HISTORIC AND DESIGN REVIEW COMMISSION

August 07, 2019

HDRC CASE NO: 2019-409
ADDRESS: 818 N OLIVE ST
LEGAL DESCRIPTION: NCB 540 BLK 11 LOT A15
ZONING: R-5, H
CITY COUNCIL DIST.: 2
DISTRICT: Dignowity Hill Historic District
APPLICANT: Sue Ann Pemberton/Mainstreet Architects Inc.
OWNER: Jaqueline Roberts/BIGLEY RYAN
TYPE OF WORK: Exterior modifications, front porch modifications, window replacement, carport construction and accessory structure modifications
APPLICATION RECEIVED: July 18, 2019
60-DAY REVIEW: September 16, 2019
CASE MANAGER: Edward Hall
REQUEST:

PROPOSED SITE PLAN

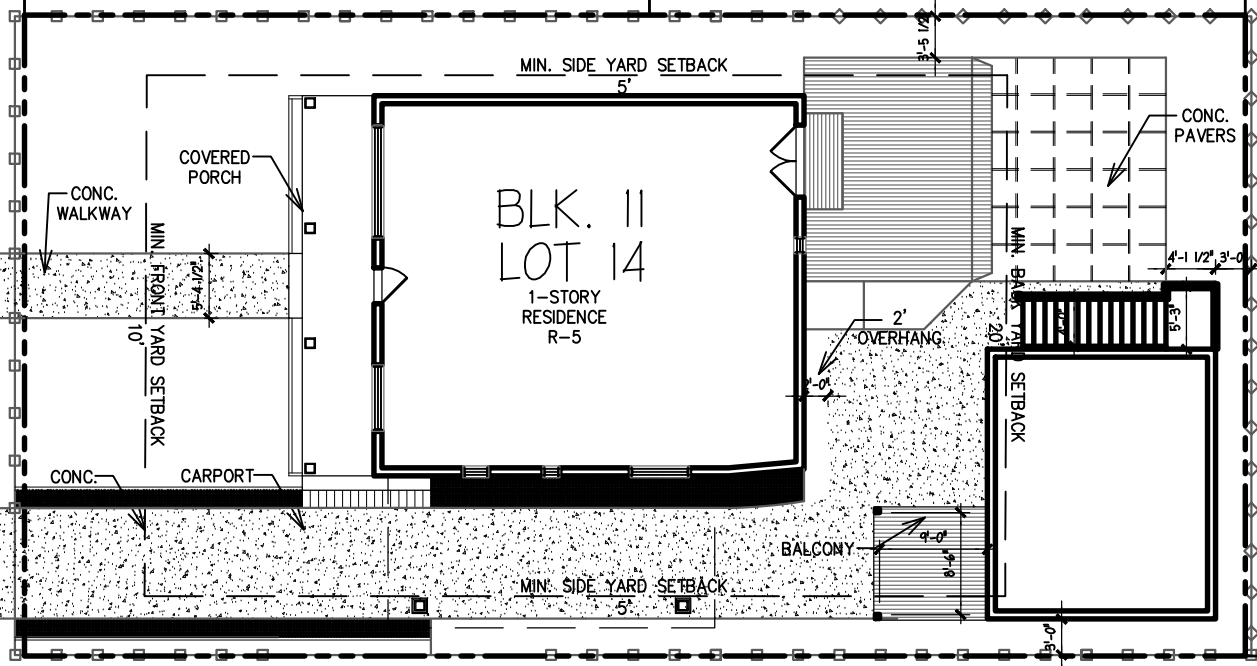
- b. CARPORT – The applicant has proposed to remove a non-original carport and construct a new carport on the south side of the historic structure. Currently, the existing carport and front porch act as one structure and read as one element. The applicant has proposed to separate the carport from the front porch and set it back from the front façade. The applicant has proposed materials that include eight inch square columns with capital and base trim, a shingle roof, and wood trim. Generally, staff finds the proposed carport removal and new construction to be appropriate; however, staff finds that the proposed carport should be detached from the historic structure.

- i. That the applicant modify the design of the proposed carport so that it is detached from the historic structure.
- ii. That the proposed architectural details of the porch modifications be simple in nature as to not appear original.

WEST ELEVATION

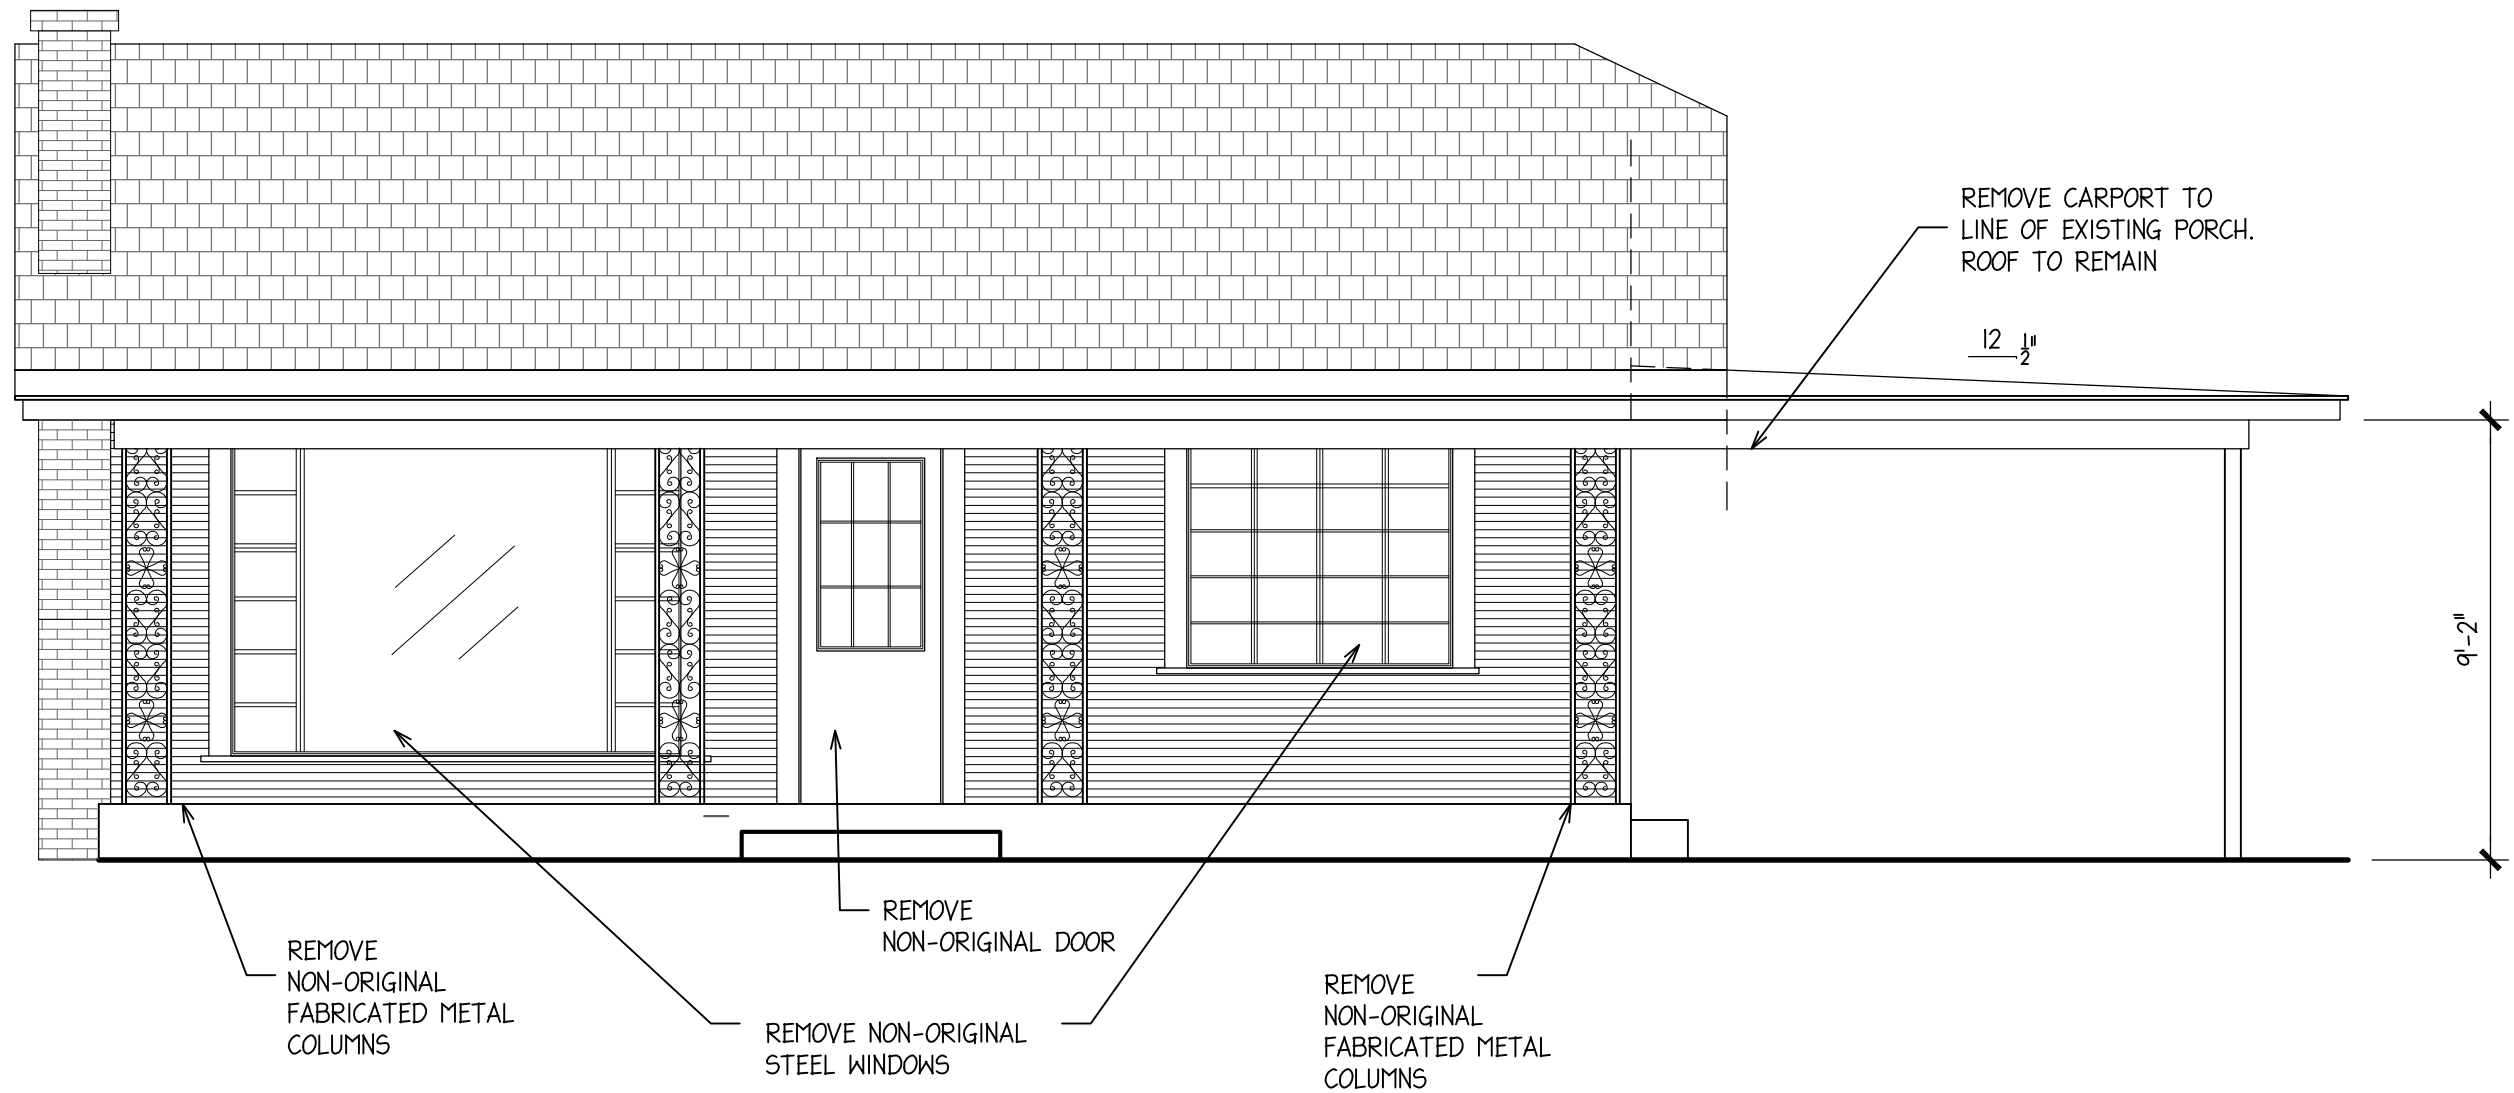
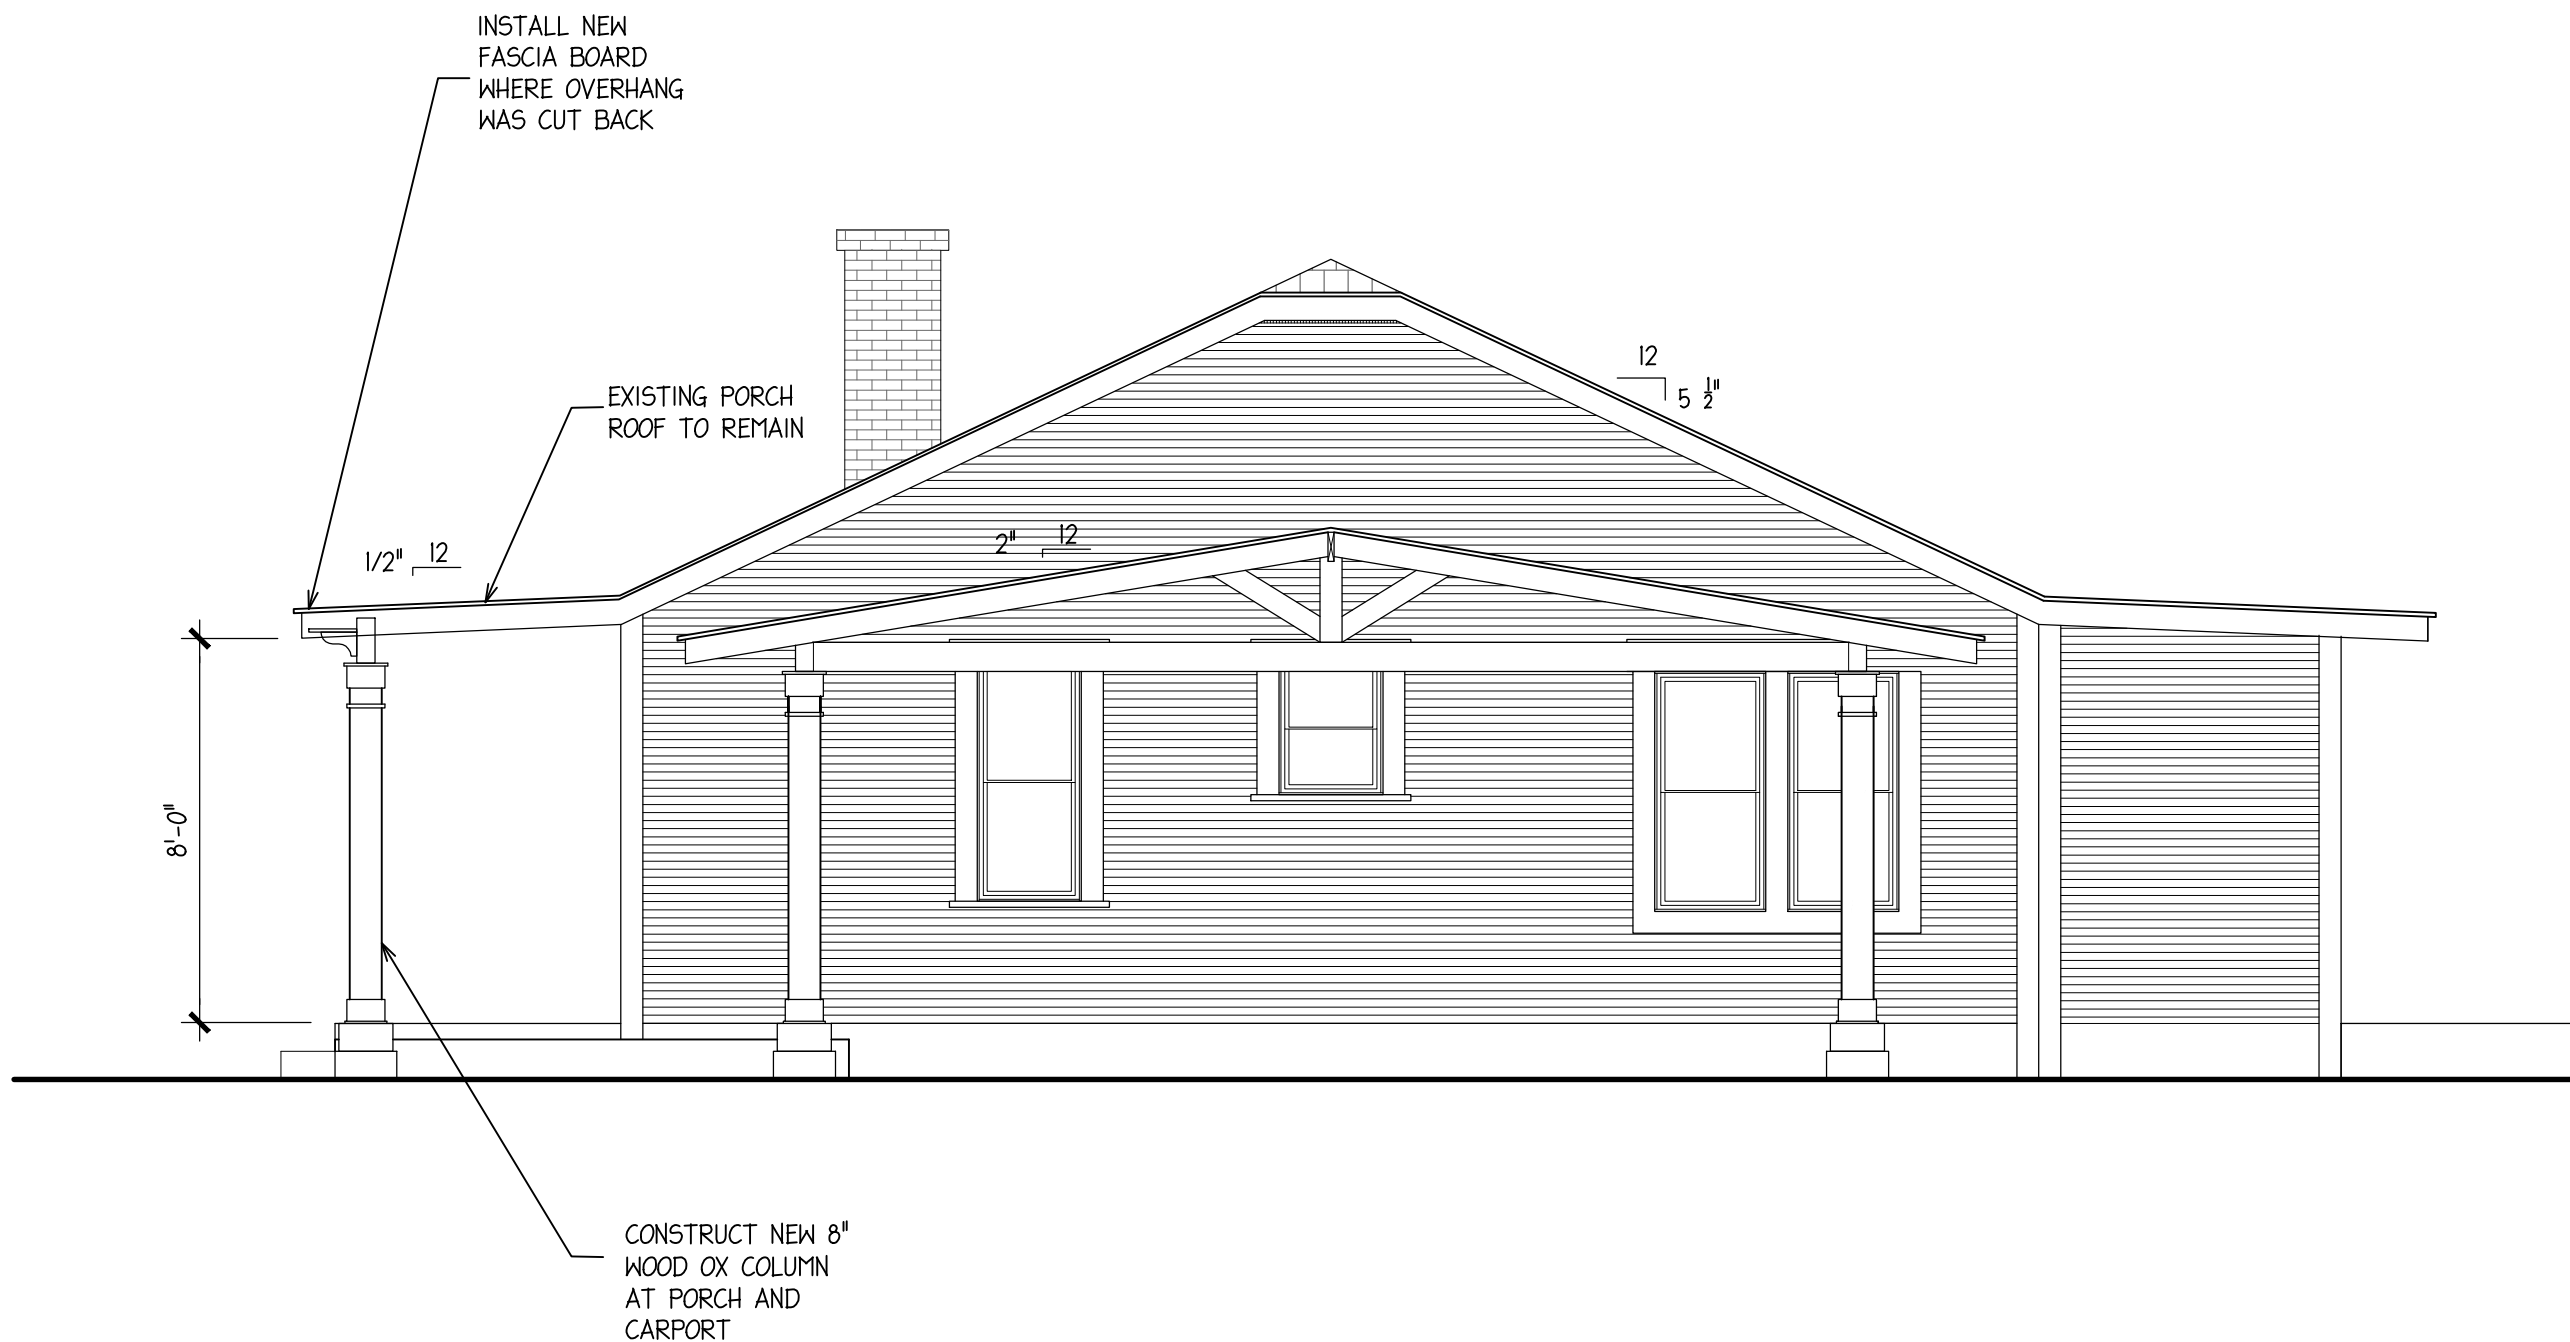
- c. PORCH COLUMNS – The applicant has proposed to remove the existing, non-original wrought-iron porch columns and install eight inch square wood columns. The proposed columns are to feature both capital and base trim. Staff finds the proposed replacement to be appropriate.

- d. PORCH ROOF MODIFICATIONS – As noted in finding a, the original front façade and porch roofs have been modified. The applicant has proposed to modify the existing, non-original porch roof by removing a portion of the street facing overhang. Generally staff finds this to be appropriate; however, staff finds that architectural details and trim work should be simple in design as to not appear as original.

- e. WINDOW REPLACEMENT – The existing front façade features two large steel windows, both of which the applicant has proposed to replace with one over one wood windows that match those found historically on this structure. Generally, staff finds this replacement to be appropriate; however, the proposed new windows should feature head and sill heights as well as installation depths that match those found historically on this structure. Additionally, grouped windows should be separated by a wood mullion.

- f. WINDOW MATERIALS – The applicant has noted wood windows, which staff finds to be appropriate. Staff finds that the proposed wood windows should feature meeting rails must be no taller than 1.25" and stiles no wider than 2.25". White manufacturer's color is not allowed, and color selection must be presented to staff. There should be a minimum of two inches in depth between the front face of the window trim and the front face of the top window sash. This must be accomplished by recessing the window sufficiently within the opening or with the installation of additional window trim to add thickness. Window trim must feature traditional dimensions and architecturally appropriate sill detail. Window track components must be painted to match the window trim or concealed by a wood window screen set within the opening.

- g. DOOR REPLACEMENT – The applicant has proposed to replace the existing front door, which is a vinyl door with nine lites. The applicant has not specified the door that is to be installed. Staff finds that a wood door with appropriate detailing for a Craftsman structure should be installed.

- iii. That the proposed replacement windows feature head and sill heights that match those found historically on the structure and that the grouped windows are separated by a wood mullion. This detail should match those found elsewhere on the historic structure.

- iv. That the proposed wood windows meet the following specifications: Meeting rails must be no taller than 1.25” and stiles no wider than 2.25”. White manufacturer’s color is not allowed, and color selection must be presented to staff. There should be a minimum of two inches in depth between the front face of the window trim and the front face of the top window sash. This must be accomplished by recessing the window sufficiently within the opening or with the installation of additional window trim to add thickness. Window trim must feature traditional dimensions and architecturally appropriate sill detail. Window track components must be painted to match the window trim or concealed by a wood window screen set within the opening.

- v. That a wood door consistent with the Craftsman style to submitted when returning for final approval for review and approval.
